Millom Arts and Enterprise Centre

Proposed Non Material Amendment – Planning Statement

Ground floor plan with new stair to rear corner and removal of existing stairs – toilets change to suit.

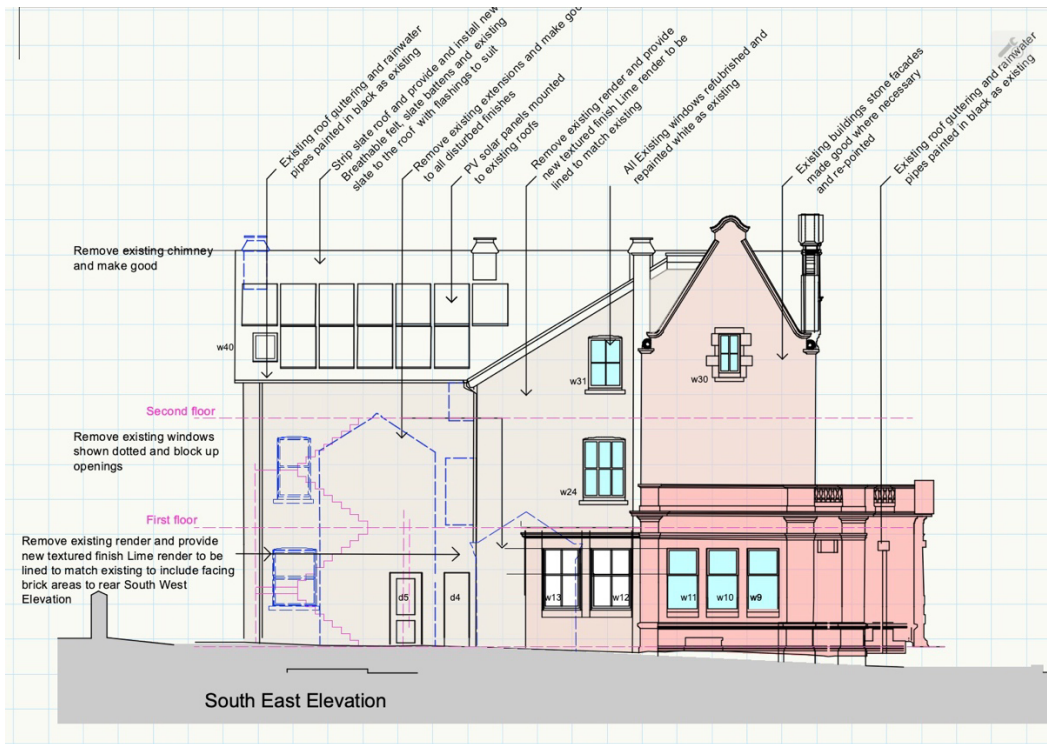
The original proposed scheme retains the existing staircases which discharge into the centre of an open plan building with no direct connection to outside.

If there was a fire at ground floor this would spread to the upper floors and potential occupants could be trapped.

We therefore have re-planned the rear section of the building to provide a new staircase in a protected shaft which includes the lift and with a door direct to outside. This would allow occupants of the upper floor in the event of a fire to escape from the building safely without passing thro' the open plan reception area.

The stair is designed to meet current building regulations in terms of width and step heights etc and also as the advantage of allowing occupants of the upper floors to access the building from a private rear door entrance out of normal hours.

The new stair would involve removal of 2/3 windows and the removal of a chimney all of which are on the back of the building.

Render finish to rear SW and SE elevation and windows removed

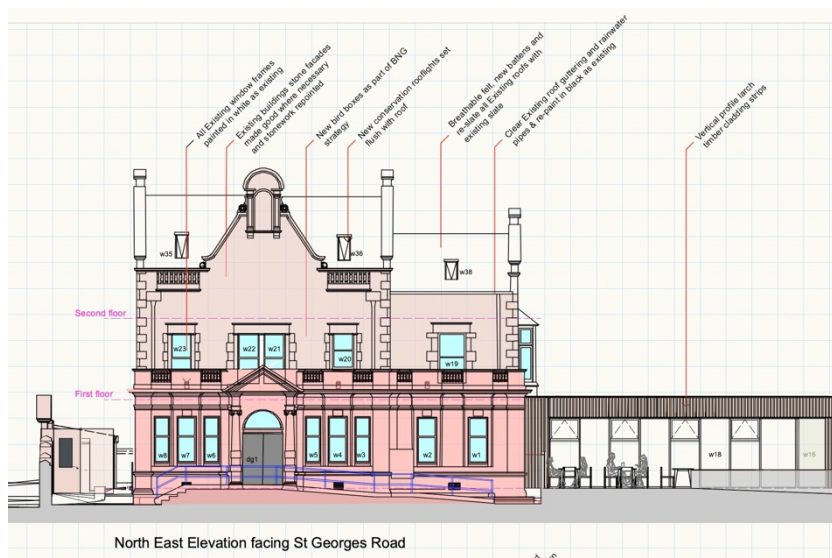
Original proposals included slate roof repairs however in view of the condition of the roof the current proposals include re-slating the whole roof with existing slates.

The basic plan and function of the building remains unchanged with minor changes to the South West elevation (removal of a window and Chimney) and South East Elevation elevations (removal of proposed 5 windows and alteration to doors).

The original proposals also included removal of the two attached outrigger extensions which when removed would leave scars on the building which a builder would need to removal internal finishes, patch in areas of abutment and former doorways and best match original facing brick. In addition the plan included removal of the existing render which is in poor condition to expose the facing brick.

We are suggesting rather than exposed brickwork it would be better to replace the existing render with a new render finish which would provide better weather proofing and cover the patched in areas.

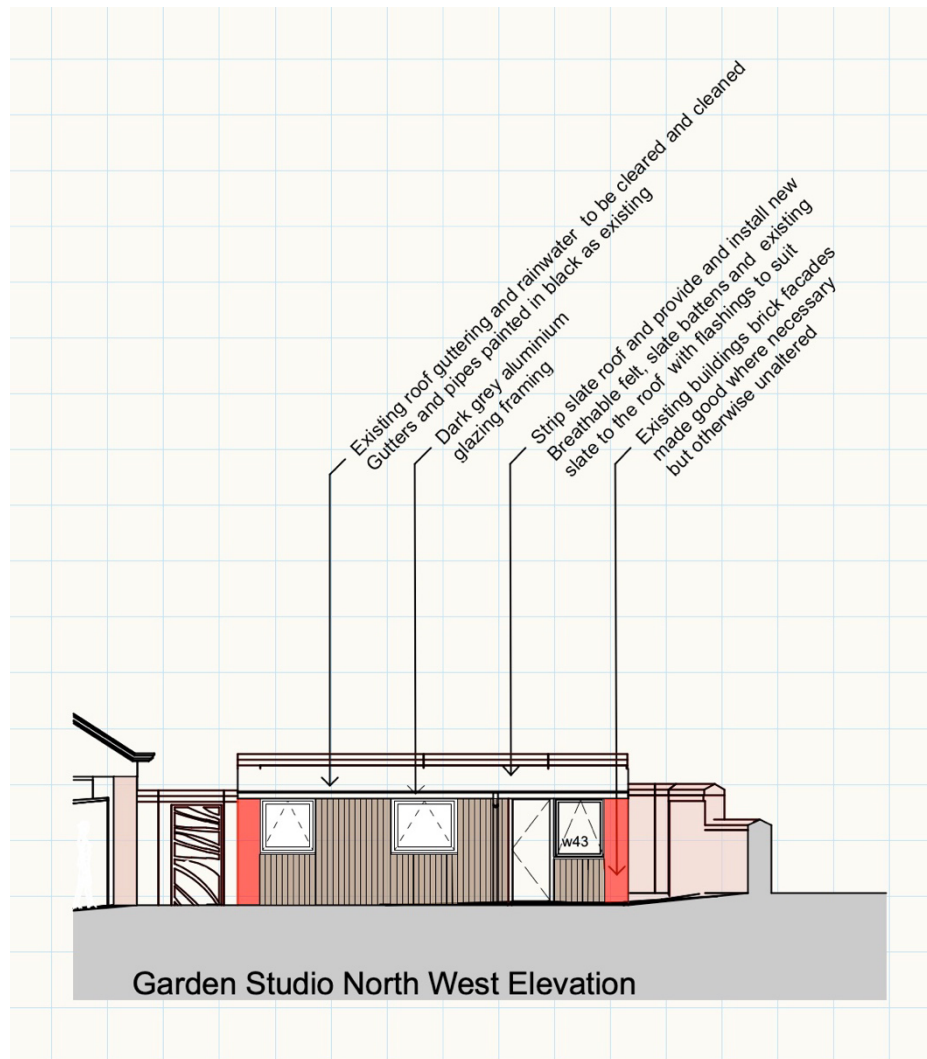
The proposals also include amendments to the café window to provide natural ventilation with opening lights introduced.

There are minor changes to the Garden Studio building with amendments to windows/doors and timber boarding
